Determination 2019/041

Regarding the provision of an accessible route to a cupola with an elevated viewing platform on a landscaped roof area at 2 Quayside, Whangarei

Figure 2: typical section tower access

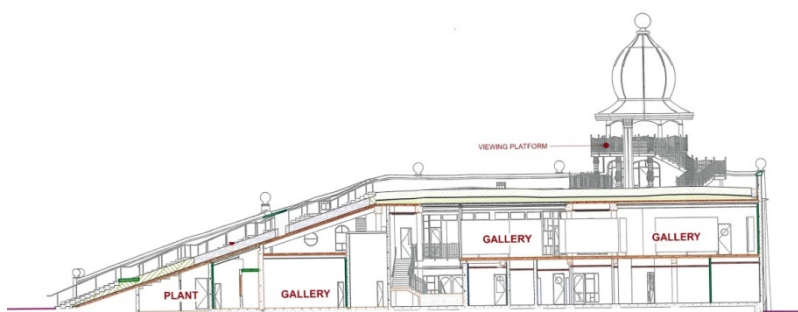
- 2.1.3 An accessible⁶ lift provides access to the first level and to the roof. The first level is 850m² and contains a café and exhibition space.
- 2.1.4 The landscaped roof area of 1053m² has an accessible pathway from the lift, traversing across the width of the landscaped roof, and the length of the roof. An accessible stair is provided from the end of the pathway to the ground level (see Figure 2 above).

- 4.3.3 With respect to the application of Clause D1.3.4 and whether a lift is required to provide access to upper floors, the applicant is of the view that the cupola structure is a separate two storey building. The authority has stated it considers the building comprises four storeys and therefore the requirement of Clause D1.3.4(c) to include a lift applies.

- 5.1 In accordance with section 188 of the Building Act 2004, I hereby determine that the proposed design does not comply with Clause D1 of the Building Code and therefore I confirm the authority's decision to refuse to grant an amendment to the building consent for the proposed design.

Figure 3: rooftop plan, showing access

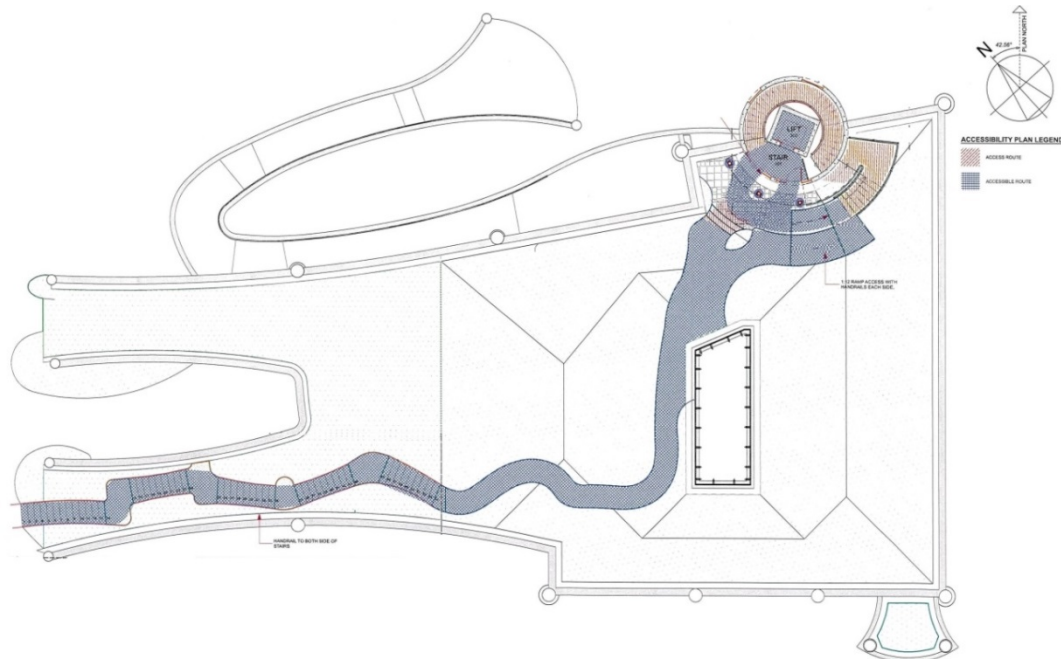
- 2.1.5 Above the lift on the landscaped roof is the cupola, which is a particular feature of the architect's style of design and incorporates a viewing platform. The floor plan for the platform (see Figure 4) shows the lift overrun takes up a significant portion of the viewing platform, and the applicant states that the remaining "usable area" of the platform is 26m². A set of accessible stairs lead from the rooftop garden up to the viewing platform.

- 4.3.7 In this case, the external landscaped roof area starts at ground level at one end of the building and as it rises forms the roof of levels below it that house the gallery. The rooftop area is accessed either by the stairs and pathway from ground level or from the interior of the building by way of the lift. Despite the fact that it does not comprise of walled-in spaces, the rooftop garden is intended to be accessed by members of the public and the activities carried out form part of the normal activities for this building, and in this way it is similar to a rooftop café or restaurant or bar. For this reason I consider the external landscaped roof area is a “storey” for the purpose of Clause D1.3.4.

- 4.3.12 I am of the view that the cupola with its viewing platform as proposed constitutes the fourth storey of this building. The viewing platform is on a higher level than the rooftop garden, being elevated some 2.5m above the rooftop, and I note in comparison that is little different to the average height of residential spaces. The cupola provides a space that will be occupied by people who wish to enjoy the views from that elevated position and experience the architectural features of the cupola.

Figure 4: viewing platform plan

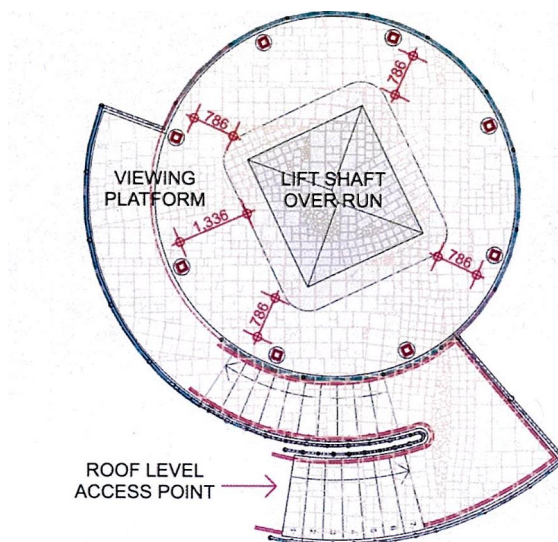
- 4.3.13 I have concluded that reasonable and adequate access includes provision of an accessible route to enable access for people with disabilities to the viewing platform. I note it could be argued that reasonable and adequate access for people with disabilities can be achieved by some means other than a lift, but that is not what has been presented in this case.
